#	Sheet Name	Sheet Issue Date	Current Revision
A000	COVER SHEET	03.14.22	
A011	LEGENDS	03.14.22	
A012	LOT AREA PLAN	03.14.22	
A020	GFA AREA DIAGRAMS EXISTING	03.14.22	
A021	GFA AREA DIAGRAMS PROPOSED	03.14.22	
A100	PROPOSED PLANS - 3/16 SCALE	03.14.22	
A105	EXISTING AND PROPOSED ROOF PLANS	03.14.22	
A201	EXISTING & PROPOSED ELEVATIONS	03.14.22	
A202	EXISTING & PROPOSED ELEVATIONS	03.14.22	
A203	EXISTING AND PROPOSED ELEVATIONS	03.14.22	
A301	BUILDING SECTION	03.14.22	
A310	UNIT 1 - STAIR SECTION AND ENLARGED PLANS	03.14.22	
A311	UNIT 2 - STAIR SECTION AND ENLARGED PLANS	03.14.22	
A401	WALL TYPES	03.14.22	
A402	FIRE RATED ASSEMBLIES	03.14.22	
A501	WINDOW ELEVATIONS & SCHEDULE	03.14.22	
S100	FRAMING PLANS	03.10.22

17 ALVESTON STREET, JAMAICA PLAIN MA  
 PERMIT PLAN  
 03.14.22

title COVER SHEET  
 project 17 ALVESTON STREET, JAMAICA PLAIN MA

file  
EXISTING AND PROPOSED THIRD FLOOR PLANS  
project  
17 ALVESTON STREET, JAMAICA PLAIN MA

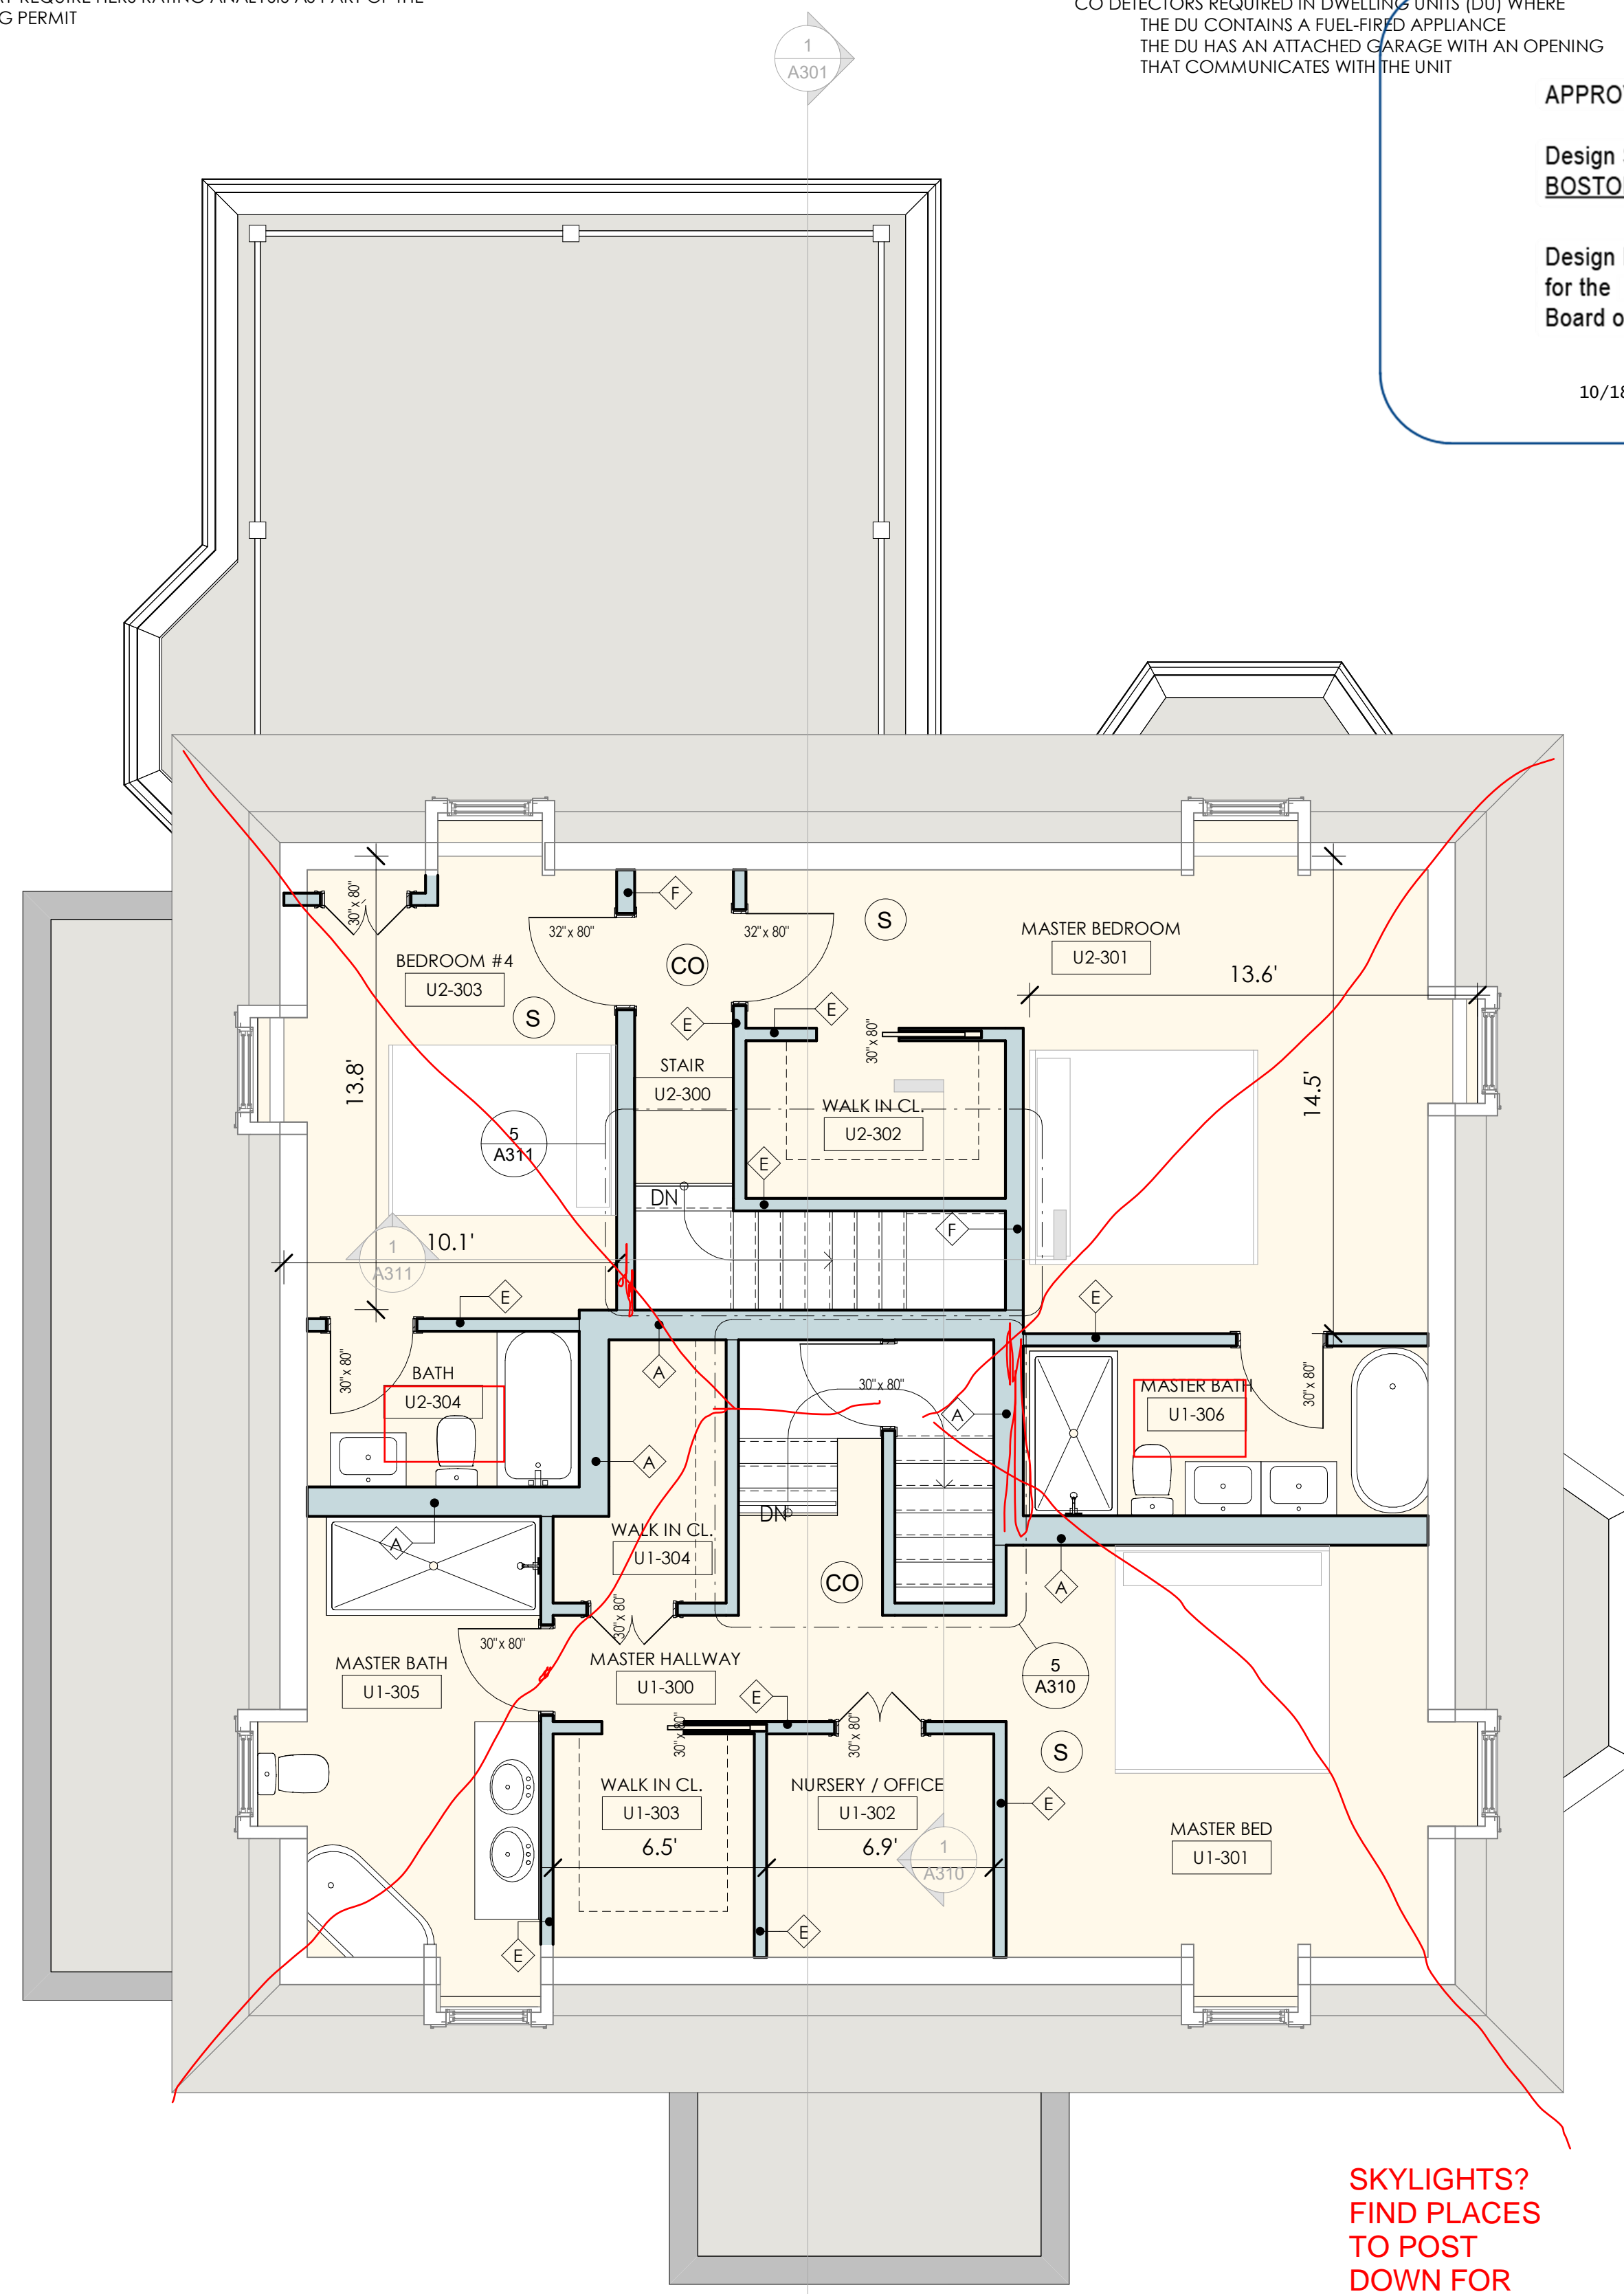
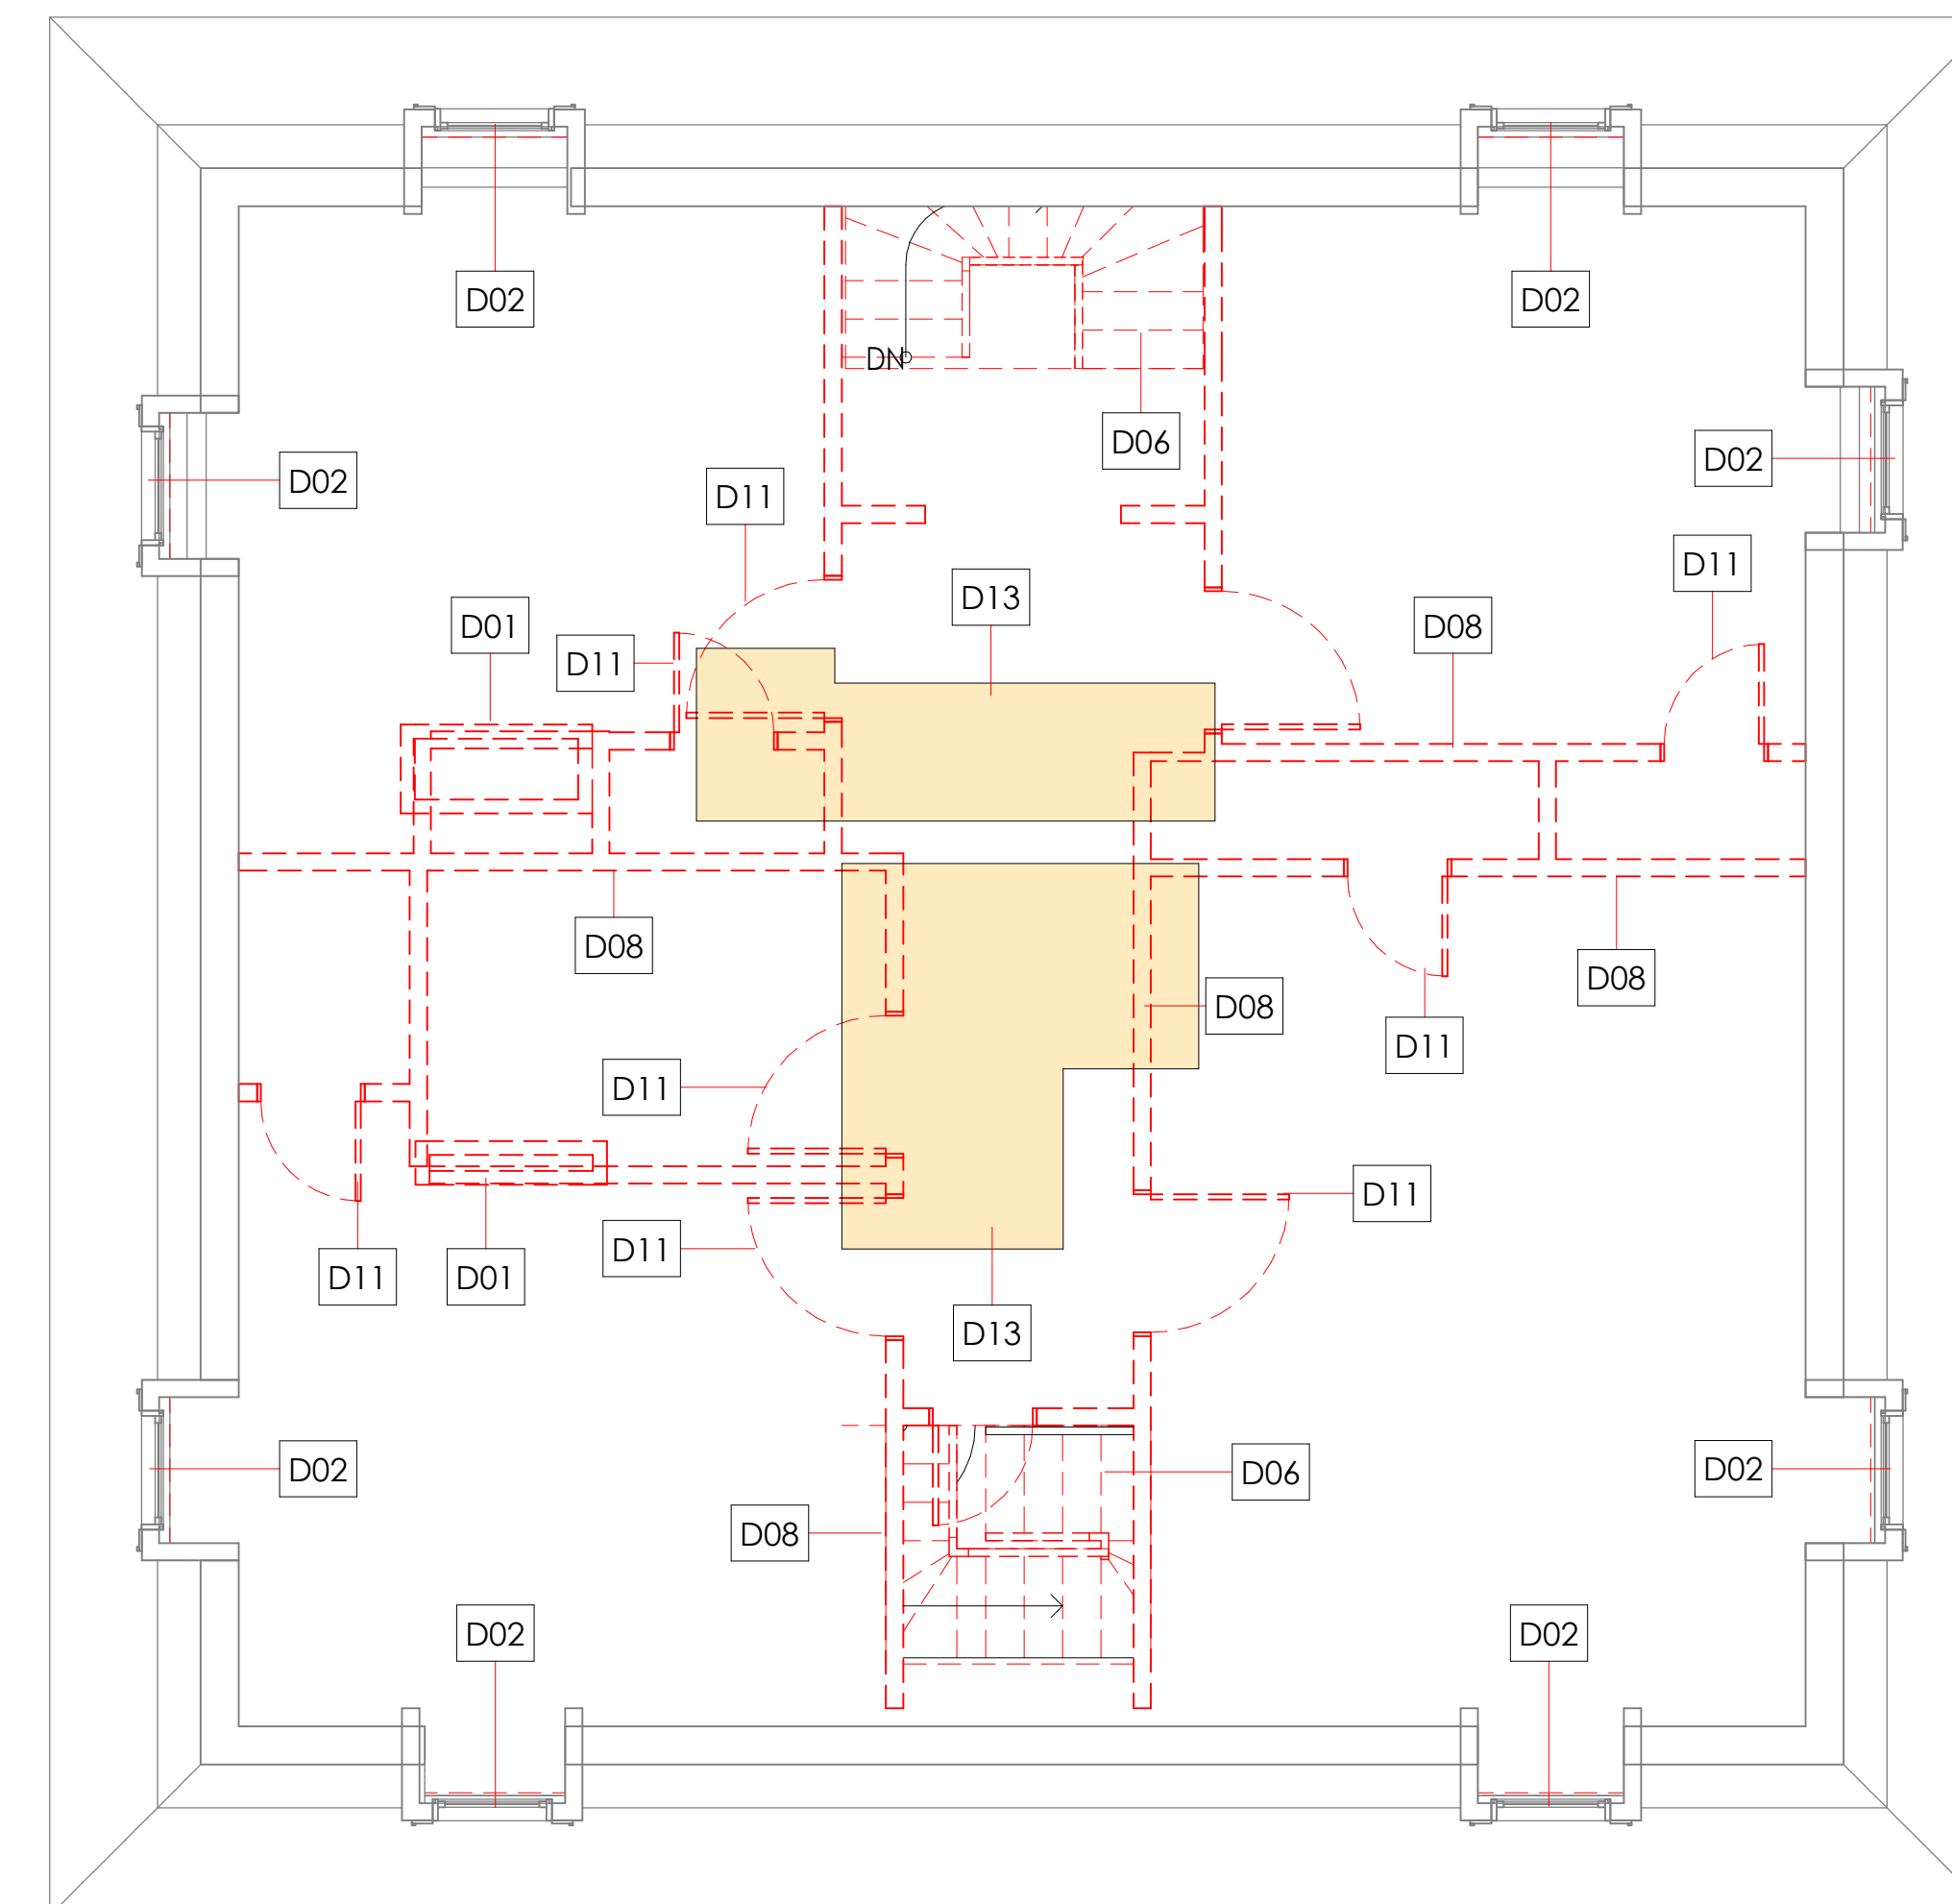
SKYLIGHTS?  
FIND PLACES  
TO POST  
DOWN FOR  
ROOF
